**CHESTNUT RIDGE PUBLIC SERVICE DISTRICT
BARBOUR COUNTY, WV**

CONTRACT #1 – WATER SYSTEM IMPROVEMENTS

ADDENDUM #1

THRASHER PROJECT #101-010-1052

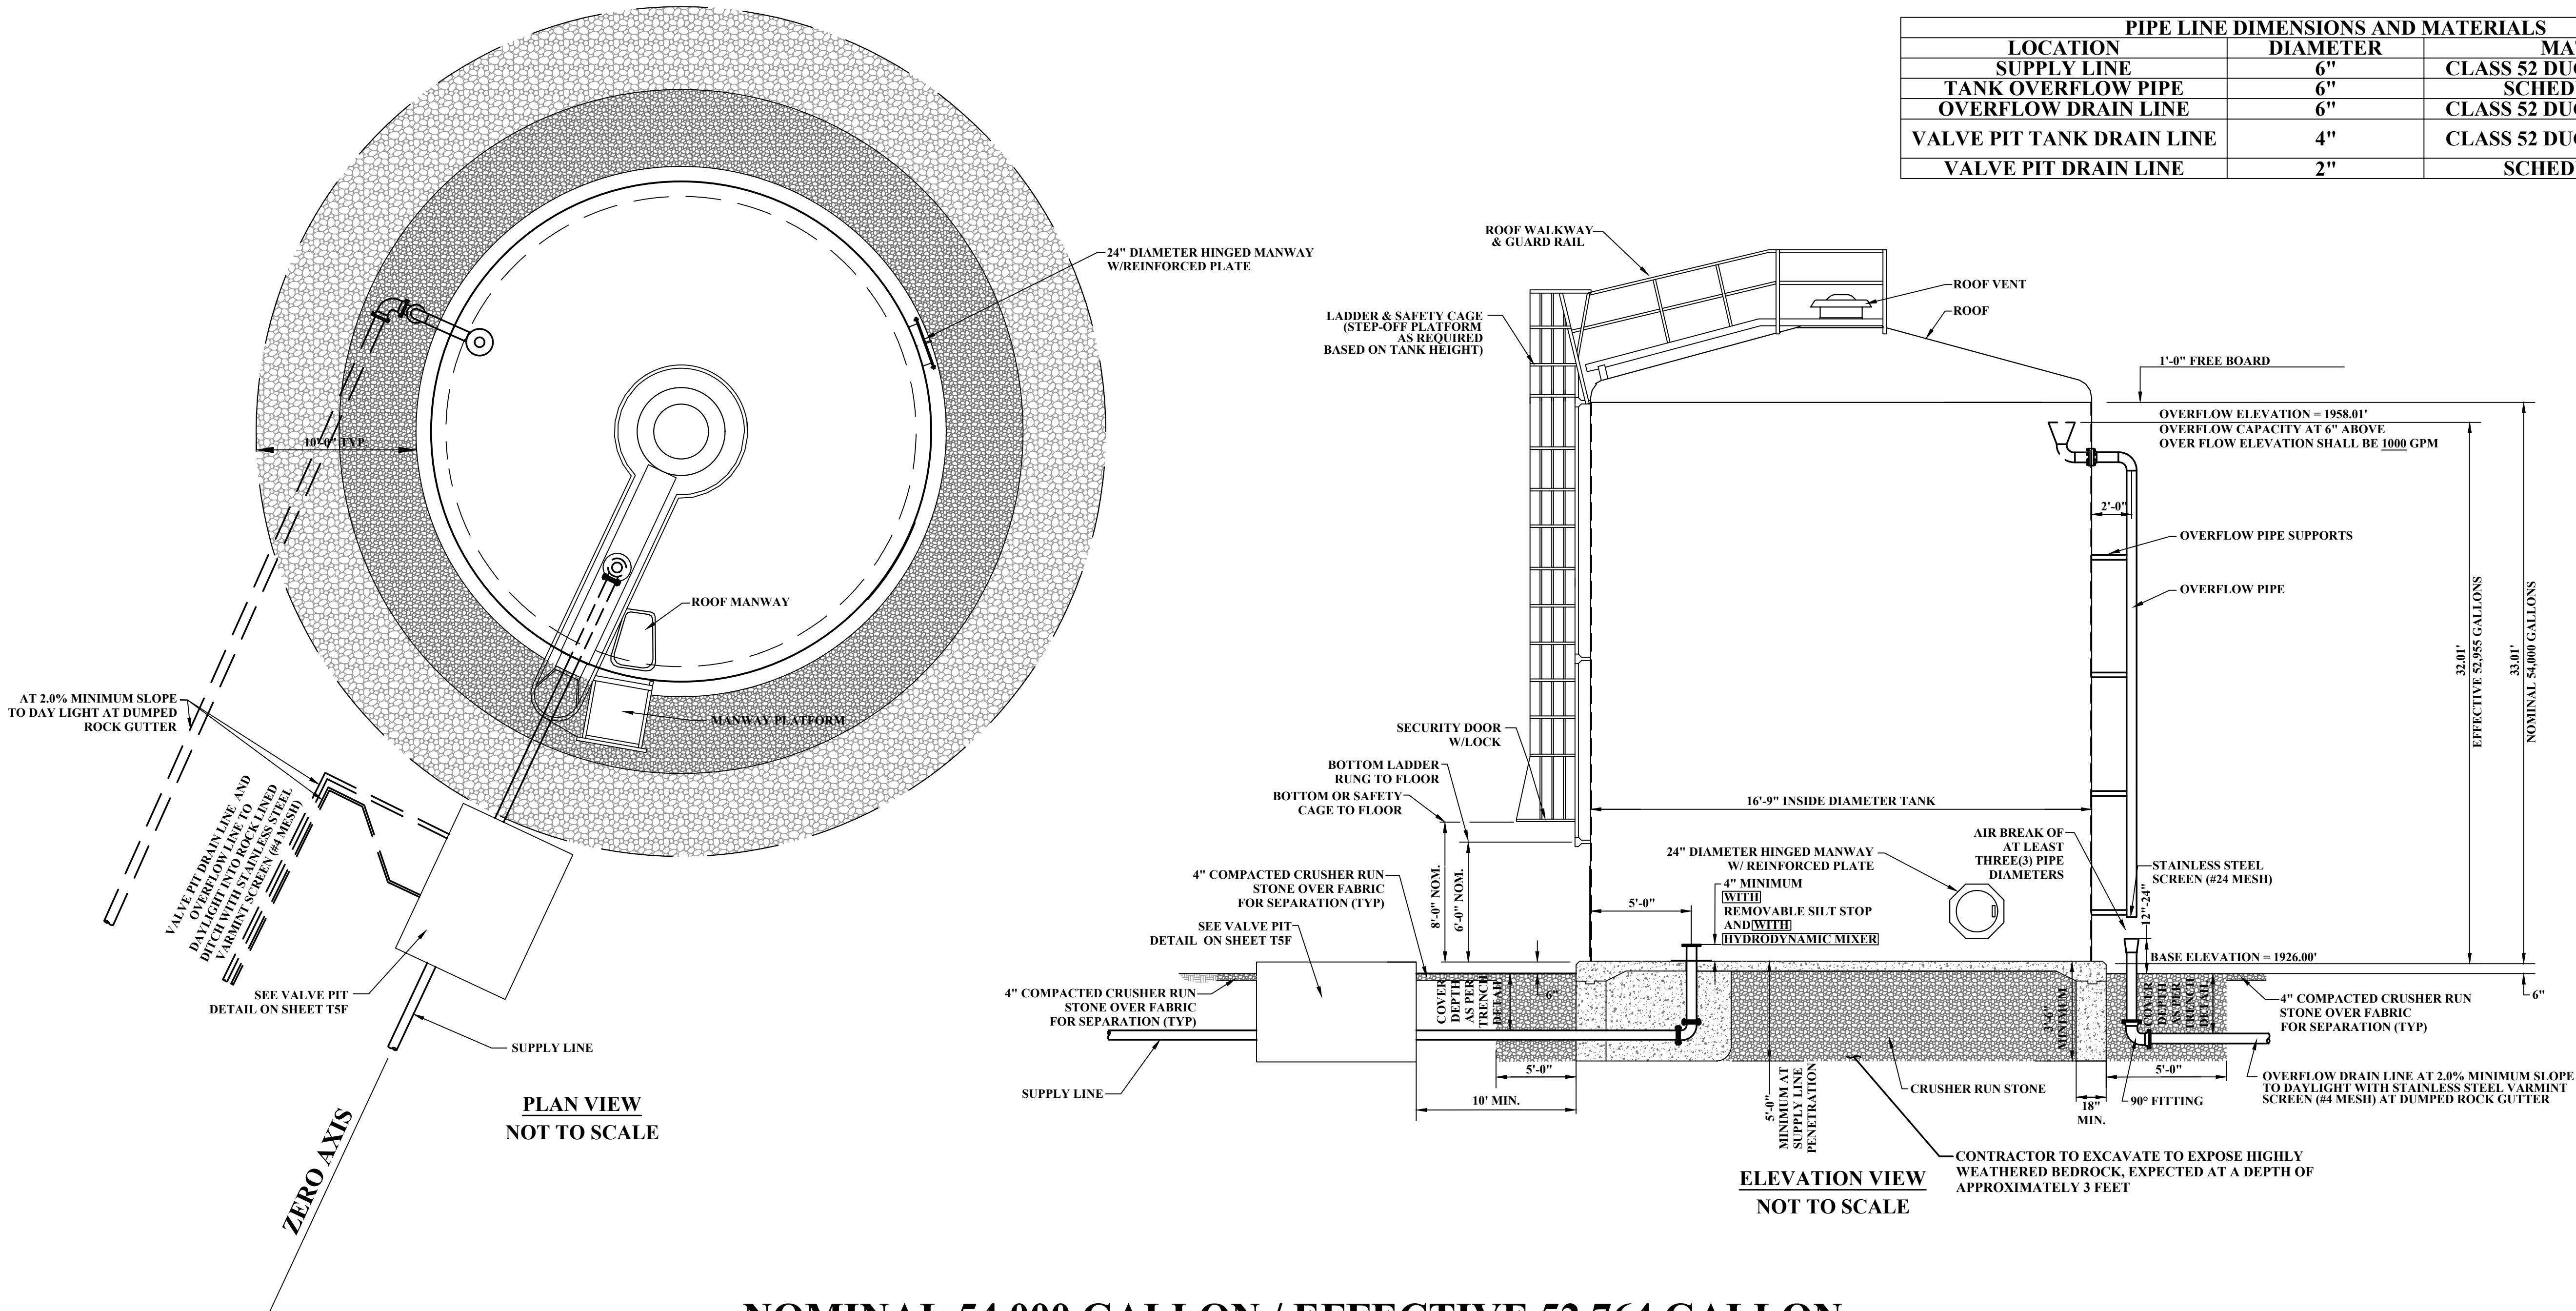
Plan Sheet T5B has been updated to correct the effective storage volume of the New Clemtown Water Storage Tank. Please discard the version previously provided and use the attached.

Plan Sheet T5D has been updated to correct the effective storage volume of the New Clemtown Water Storage Tank. Please discard the version previously provided and use the attached.
